# SS 700-WST2021 49X Vertical Exhaust Loose

# FRACAS - 13595 - 49X Dual/Split Vertical Exhaust Loose at Lower B-Pillars

Proposed Draft Production and Field service Containment proposal:

Front View  
Lower Clamp

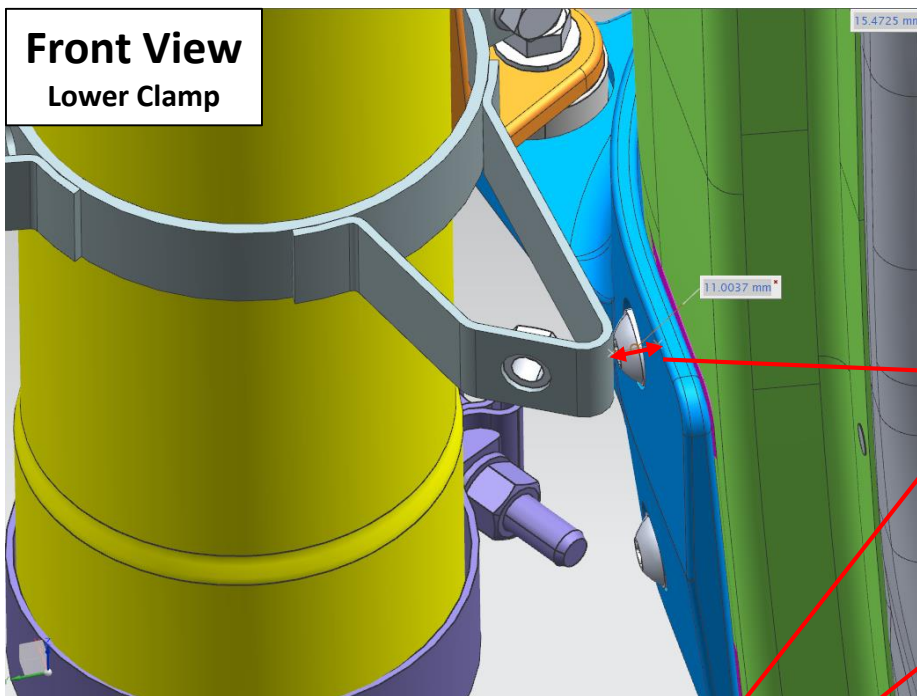
Critical that assembly is confirmed for correct torques and Key dimensions D/E Noted Below

## Lower Clamp-to-Casting Spacing Control

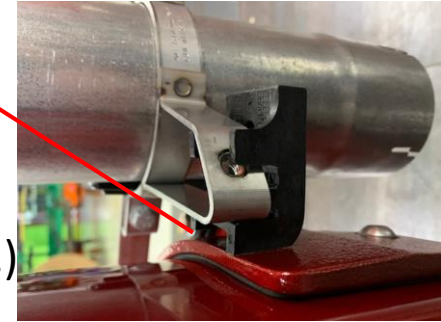
1. Remove exhaust shield
2. Loosen lower clamp to allow some rotational play in joint
3. Insert 12.5mm thick spacer block to set lower clamp-to-casting FWD spacing.
4. Torque bottom isolator fastener to 26 ft.lb.
5. Follow torque sequence below.(see next pg.)

### Exhaust fastener torque sequence

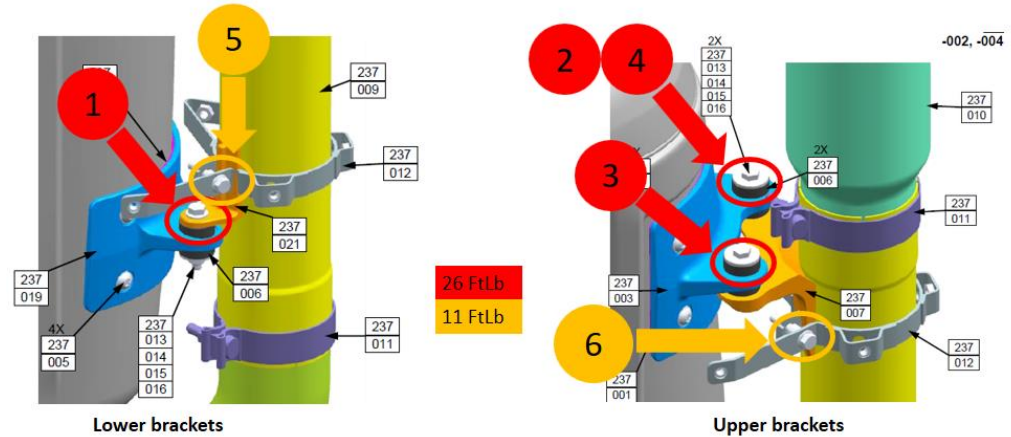
6. Check lower clamp-to-casting REAR spacing.(min. 10 mm needed to both Rear and Front bracket to ensure exhaust shield clearance to cab skin)

# Exhaust fastener torque sequence

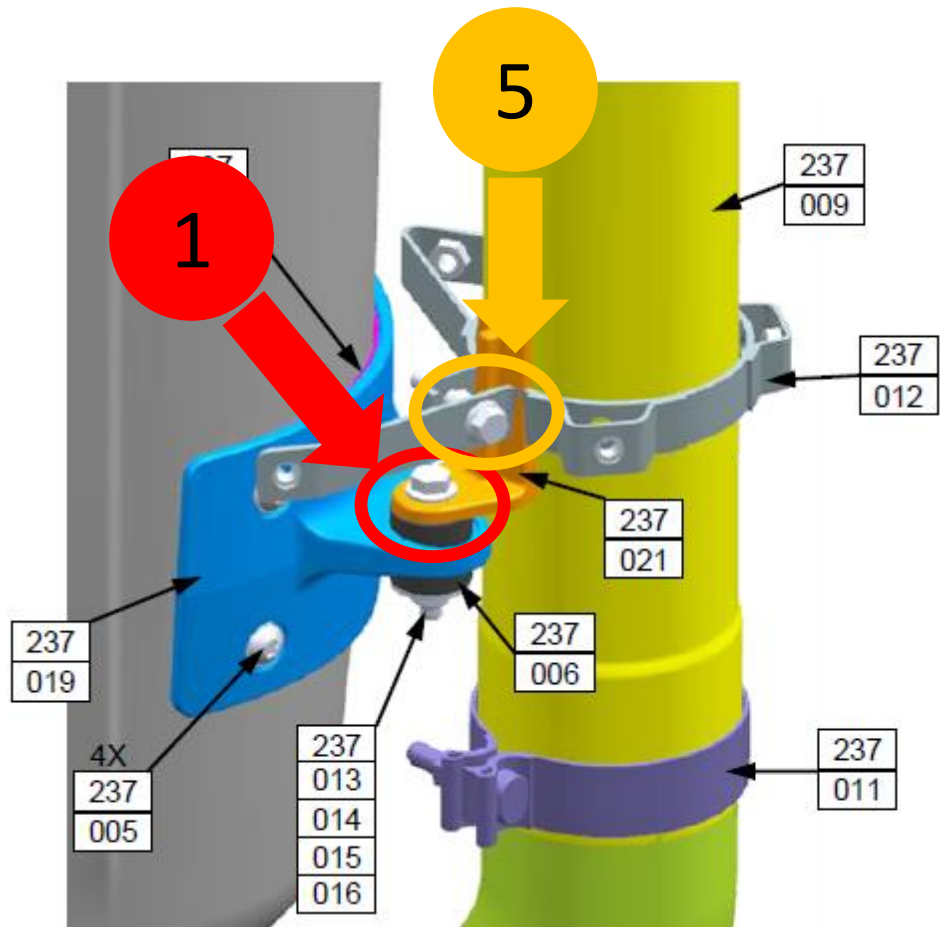
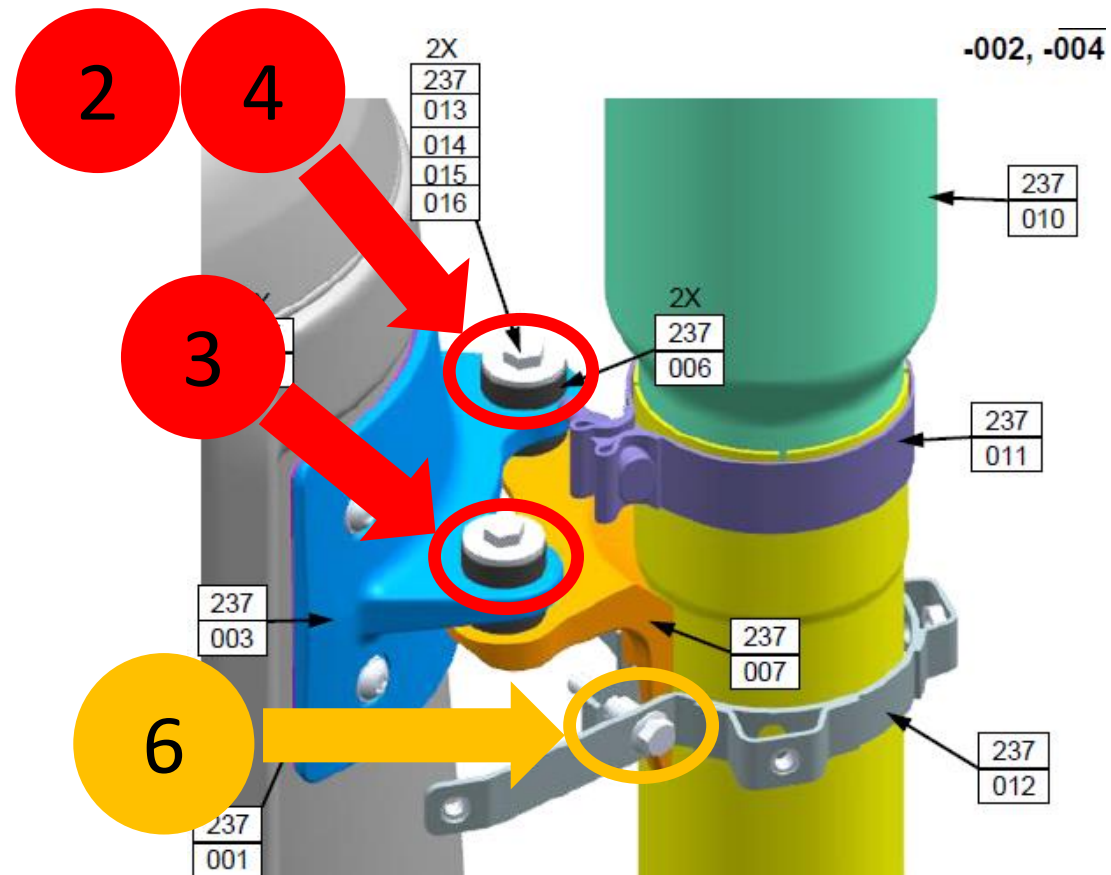
26 FtLb  
11 FtLb

# LOWER LH EXHAUST CAB BRACKET AND CLAMP MEASUREMENTS

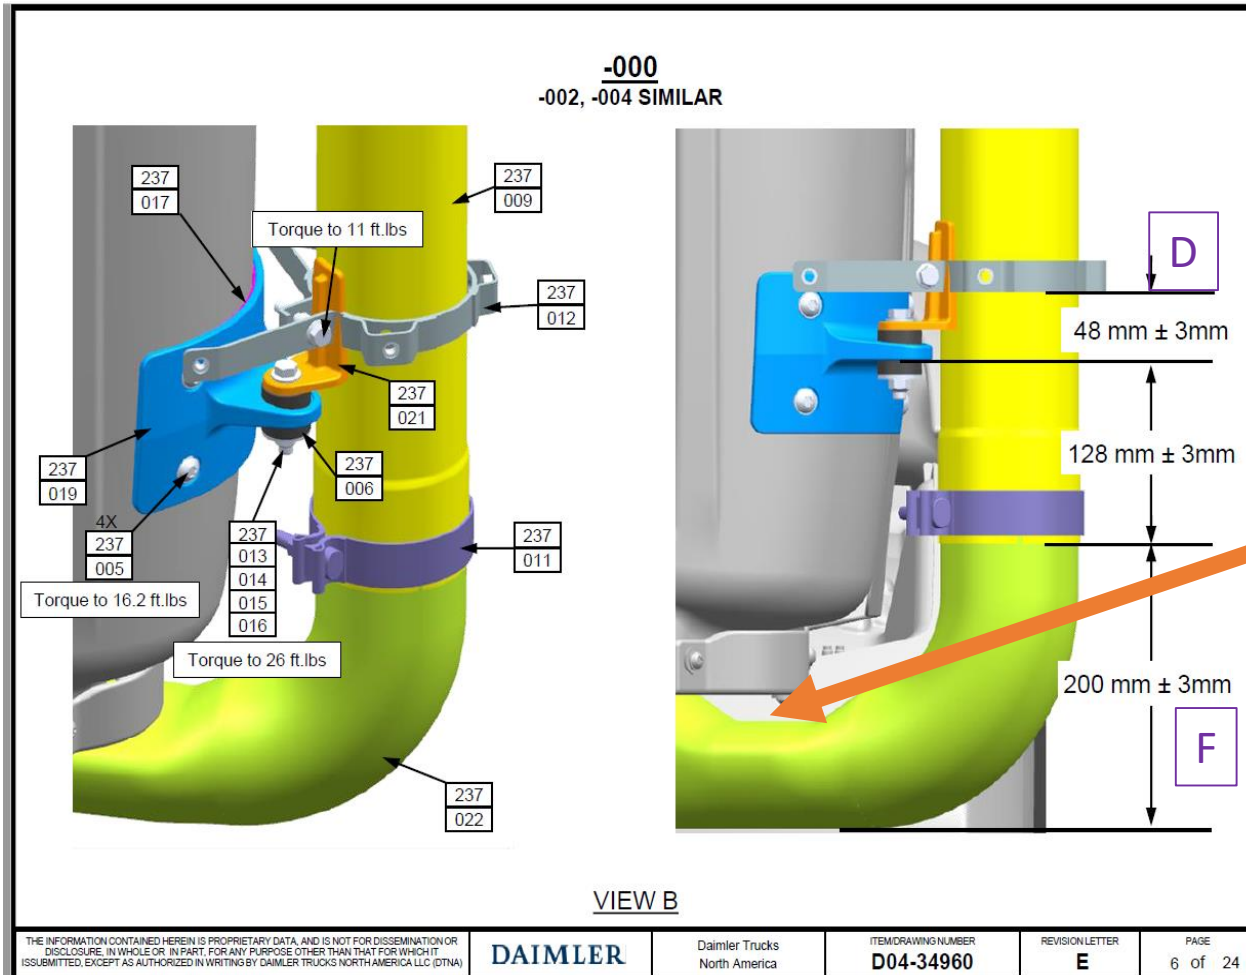
**OK:**  
**Target:** 12.5mm  
**Actual:** 12mm

**NOK:**  
**Actual:** 8.5mm

Gap Needs to be Minimum of 10MM at Front and Back to avoid exhaust shield contact to cab
